Subject: Oconee Nuclear Station, Units 1, 2, and 3  
Dockets Nos. 50-269,270, and 287  
License Amendment Request: Adoption of GL 96-03,  
"Relocation of the Pressure Temperature Limit Curves  
and Low Temperature Overpressure Protection System  
Limits" and TSTF-419-A, Rev. 0, "Revise PTLR  
Definition and References in ISTS 5.6.6, RCS PTLR"  
Technical Specification Change Number 2005-04

Pursuant to 10 CFR 50.90, Duke Energy Corporation (Duke) hereby requests an amendment to its Renewed Facility Operating Licenses DPR-38, DPR-47 and DPR-55 for Oconee Nuclear Station (ONS), Units 1, 2, and 3, respectively. The proposed change will create a Pressure and Temperature Limits Report (PTLR) based on the guidance provided in Generic Letter (GL) 96-03 "Relocation of the Pressure Temperature Limit Curves and Low Temperature Overpressure Protection System Limits" and TSTF-419-A, Rev. 0, "Revise PTLR Definition and References in ISTS 5.6.6, RCS PTLR." The proposed change relocates the Pressure Temperature Limit (PTL) Curves of Technical Specification (TS) 3.4.3 to the Selected Licensee Commitments (SLC) Manual and adds TS section 5.6.9 to reflect the GL requirements for the relocation.

ATT

Figure 3.4.3-1 (page 1 of 1)  
RCS Normal Operational Heatup Limitations  
Applicable for the First 33 EFPY - Oconee Nuclear Station Unit 1

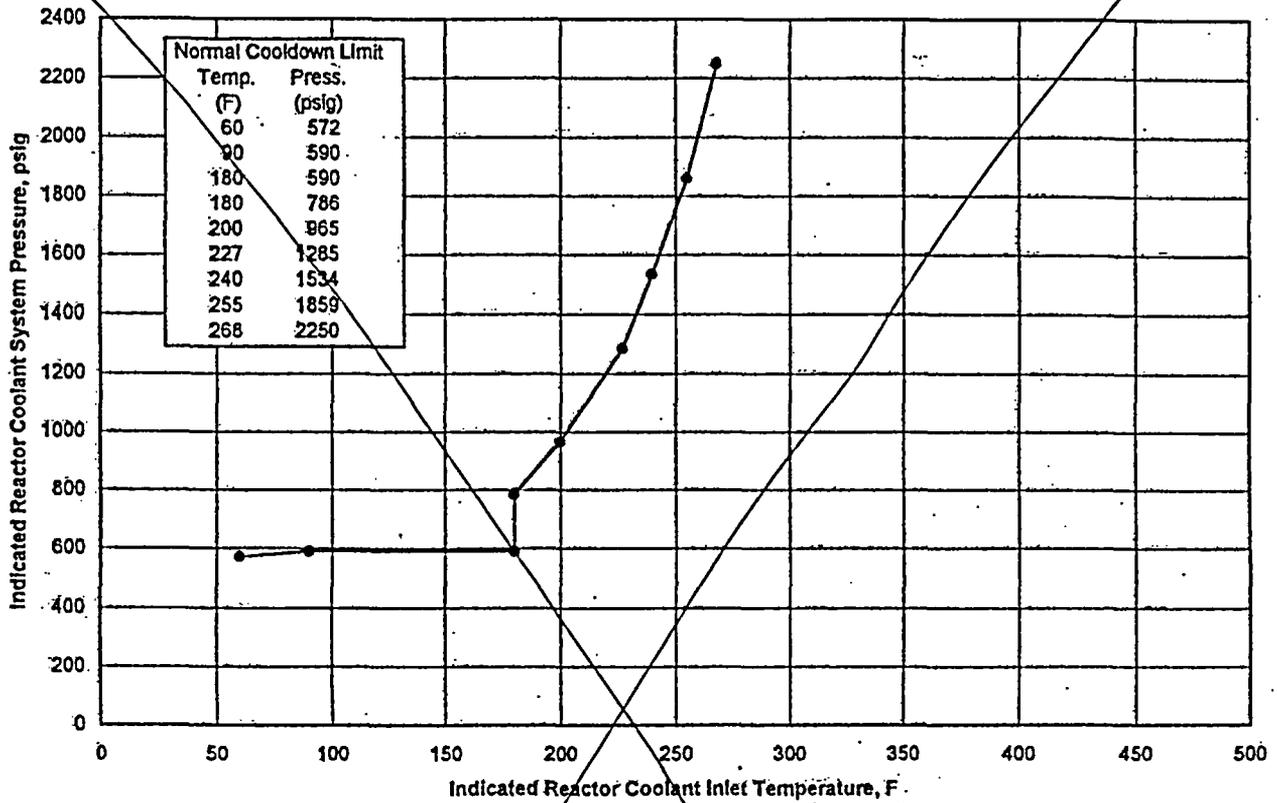
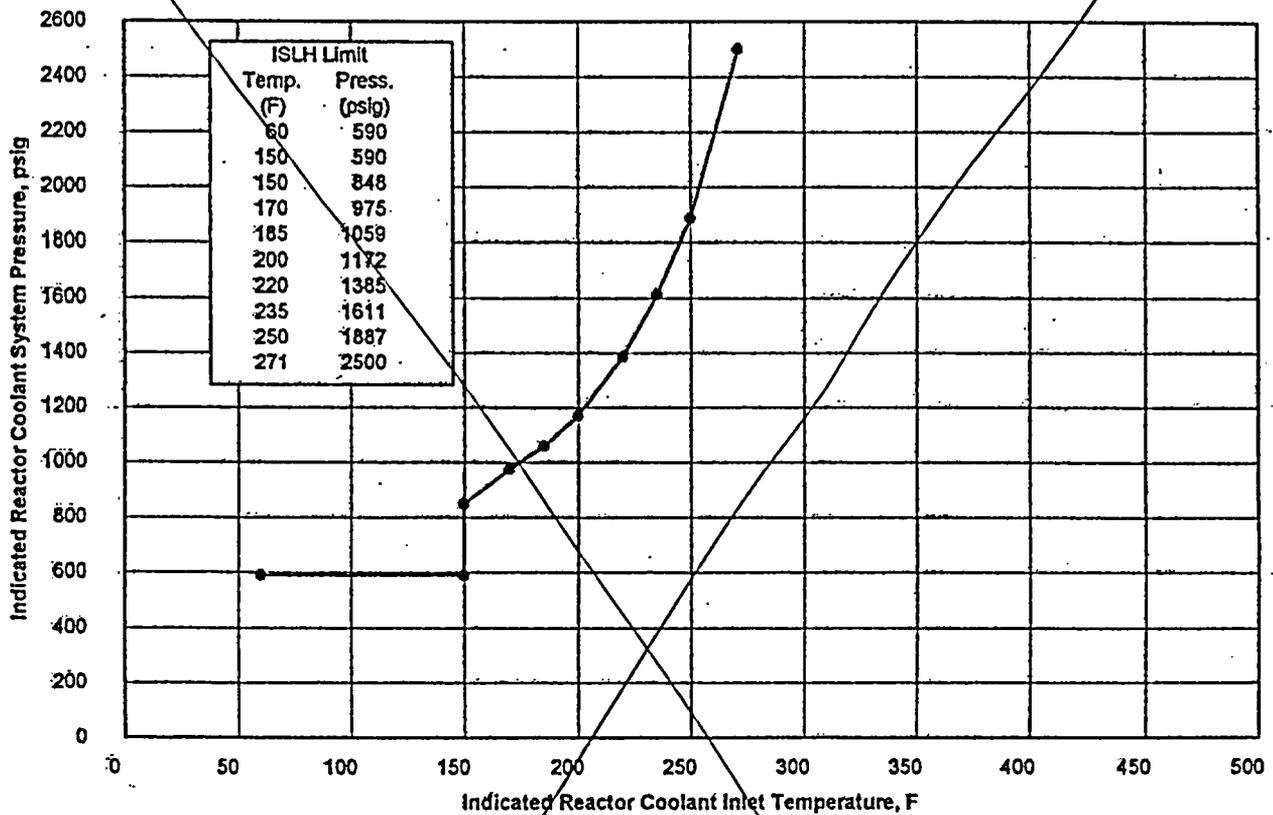
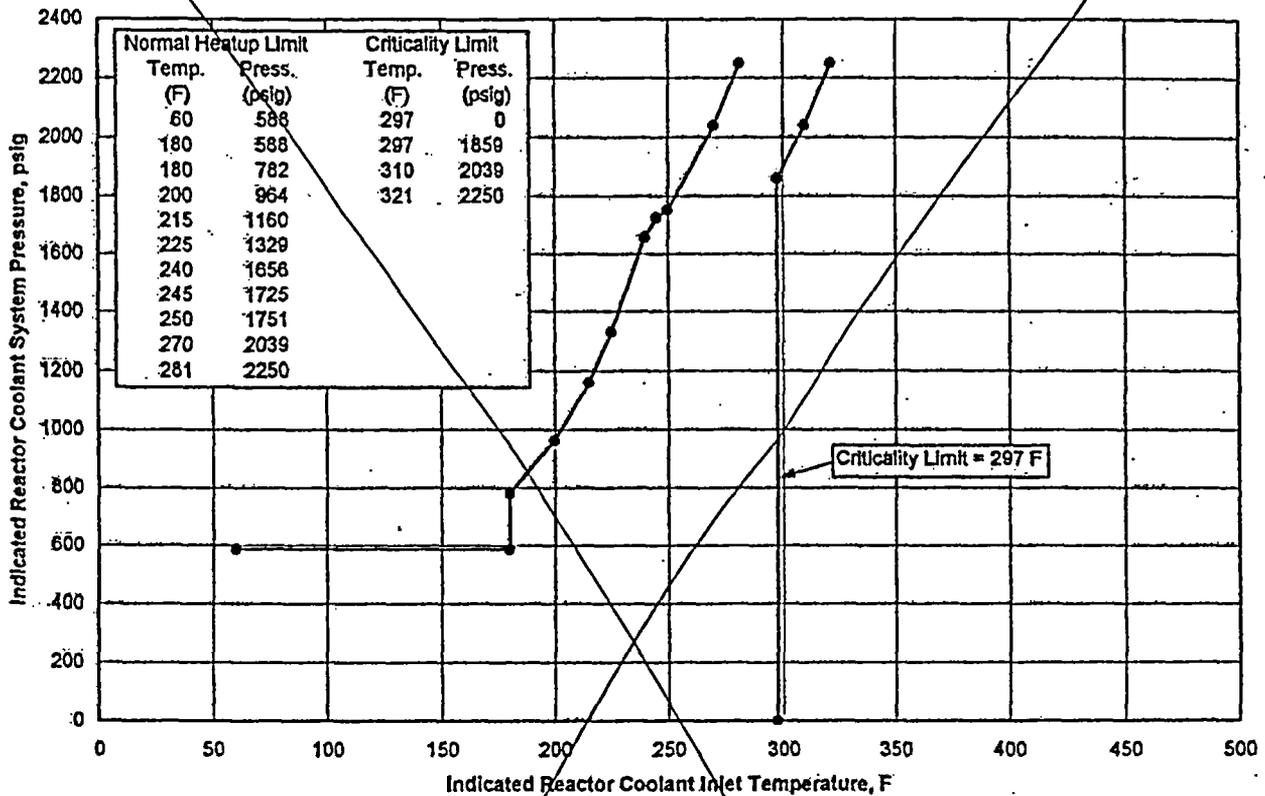
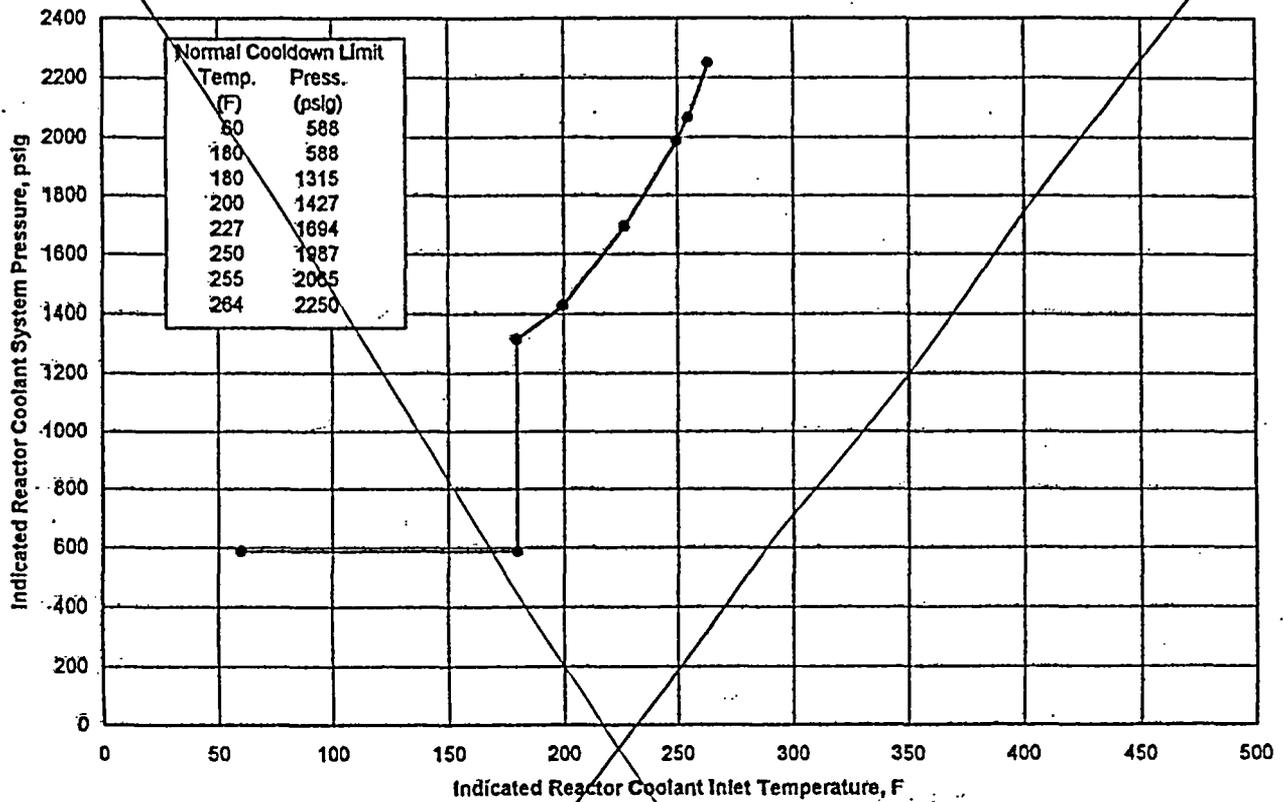
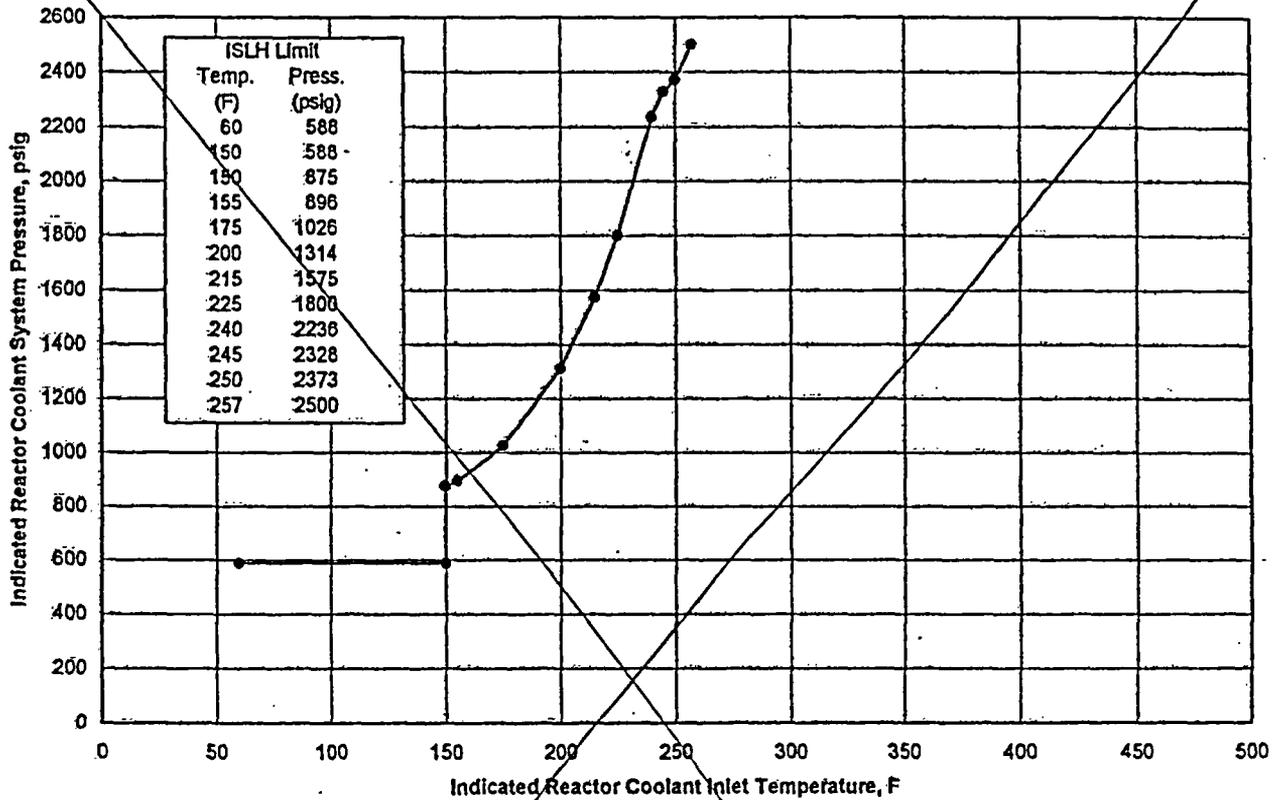
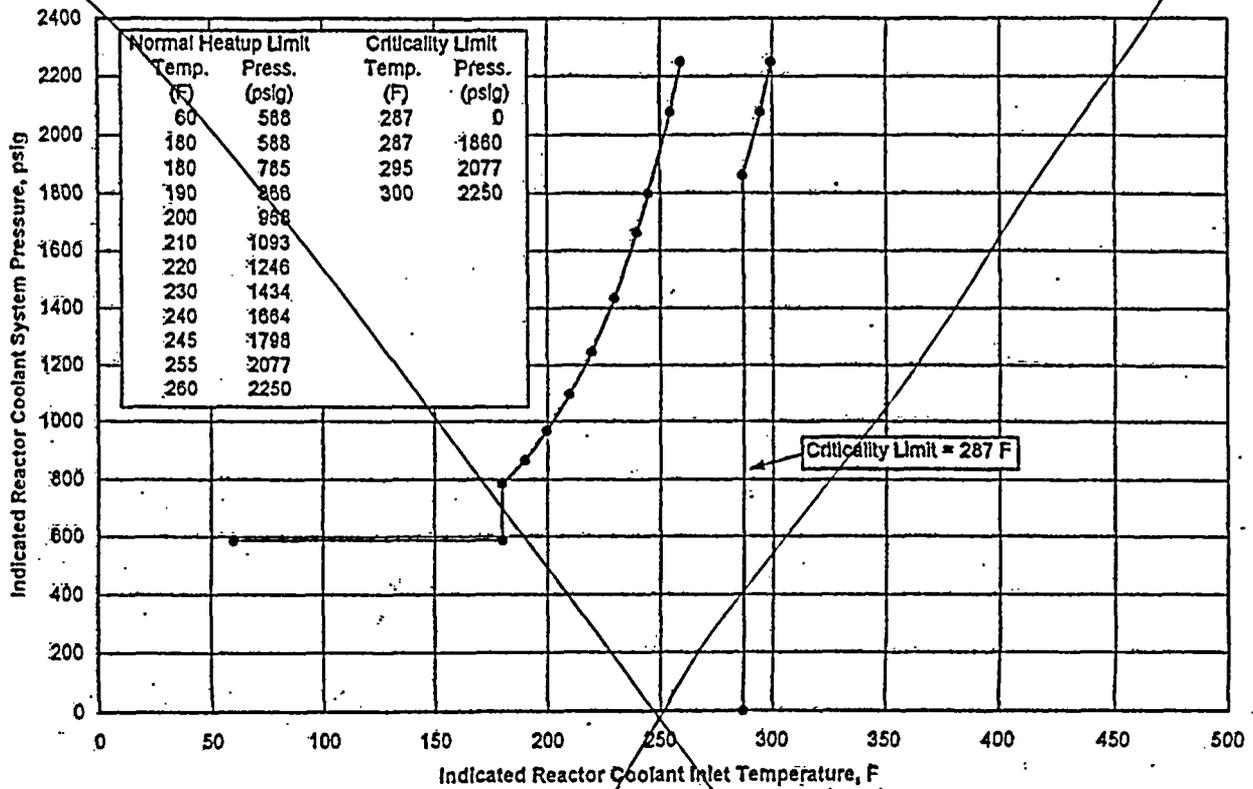
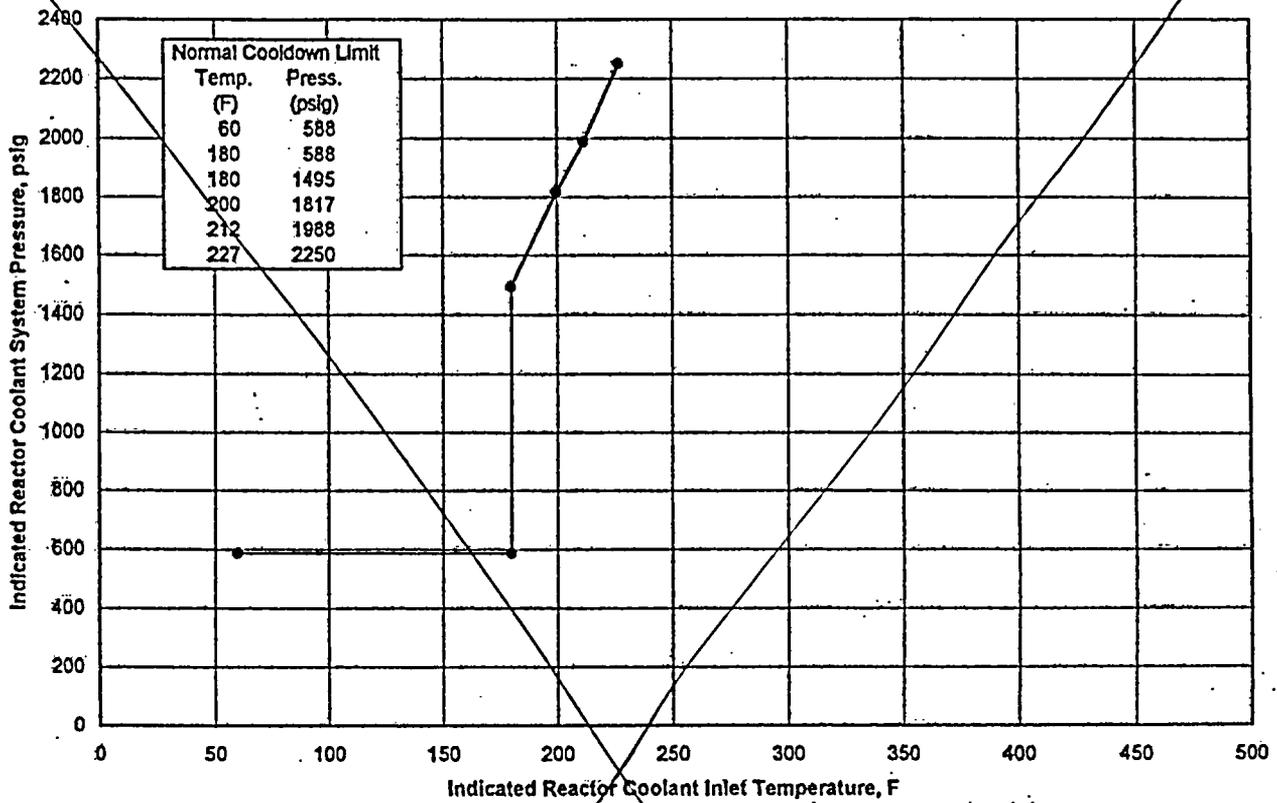
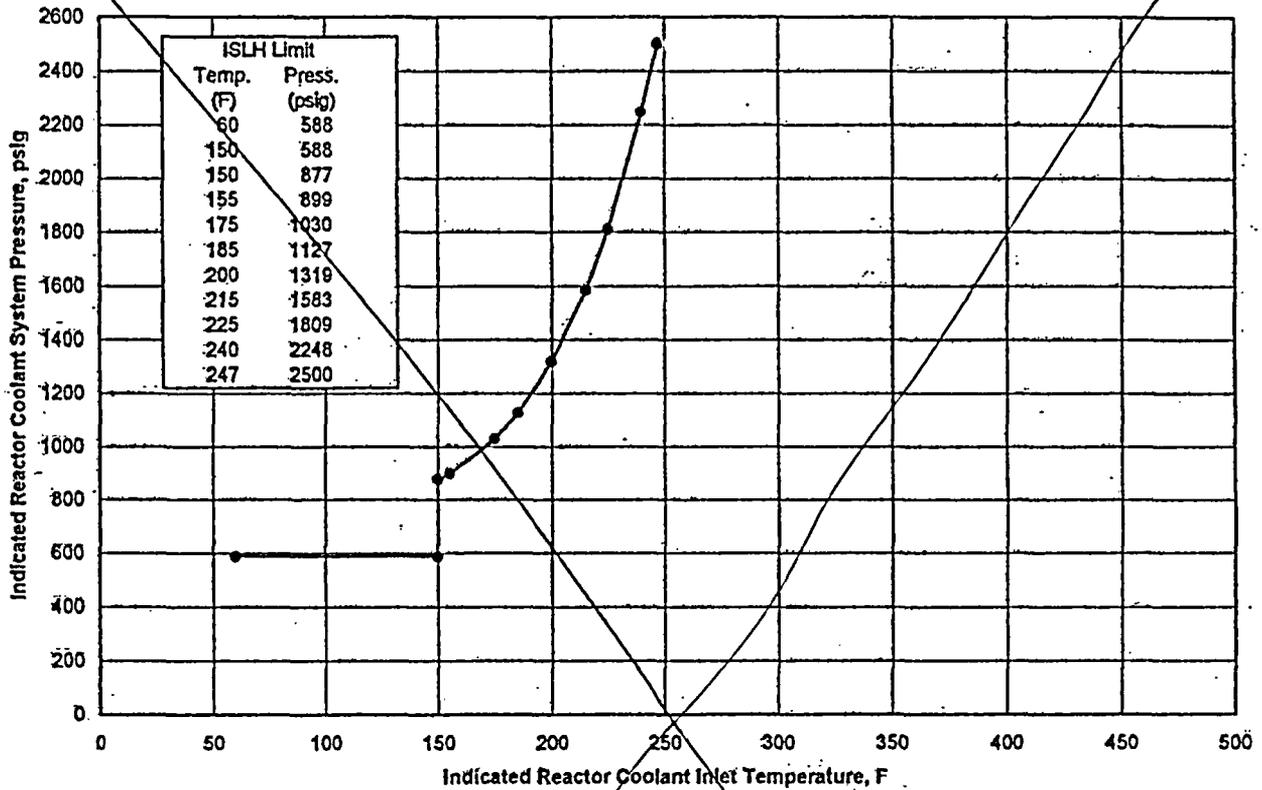
- ~~NOTES~~
1. ~~For leak tests of the RCS, leak tests of connected systems required by Specification 5.5.3 where RCS allowable combinations of temperature and pressure are controlling the RCS may be pressurized to within the limits of Figure 3.4.3-3 for Unit 1, Figure 3.4.3-6 for Unit 2 and Figure 3.4.3-9 for Unit 3.~~
  2. <sup>Tech A</sup> ~~For thermal steady state system hydro tests required by ASME Section XI the RCS may be pressurized to within the limits of Specification 2.1.2 and Figure 3.4.3-3 for Unit 1, Figure 3.4.3-6 for Unit 2 and Figure 3.4.3-9 for Unit 3.~~
  3. ~~Not applicable to the pressurizer.~~

*The PTLR*  
~~Figures 3.4.3-1 through 3.4.3-9 contain P/T limit curves for heatup, cooldown, and leak and hydrostatic (LH) testing. Tables 3.4.3-1 and 3.4.3-2 contain data for the maximum rate of change of reactor coolant temperature. The minimum temperature indicated in the P/T limit curves and tables of 60°F is the lowest unirradiated nil ductility reference temperature (RT<sub>NDT</sub>) of all materials in the reactor vessel. This temperature (60°F) is the minimum allowable reactor pressure vessel temperature if any head closure stud is not fully detensioned. There is no minimum allowable temperature limit for the reactor vessel if all of the studs are fully detensioned.~~  
*(Ref. 1)*

This proposed amendment will relocate the results of the above amendment, i.e. revised curves for Pressure Temperature Limits currently contained in TS 3.4.3 to a Pressure Temperature Limits Report (PTLR). The results will be located in the Selected Licensee Commitments (SLC) manual. Similar to the current TS format, the new SLC will contain individual PT curves for each of the Oconee units.

TS 3.4.3, RCS Pressure and Temperature Limits is being revised to remove the PTL parameters and curves from the TS. They will be included by reference in the LCO.
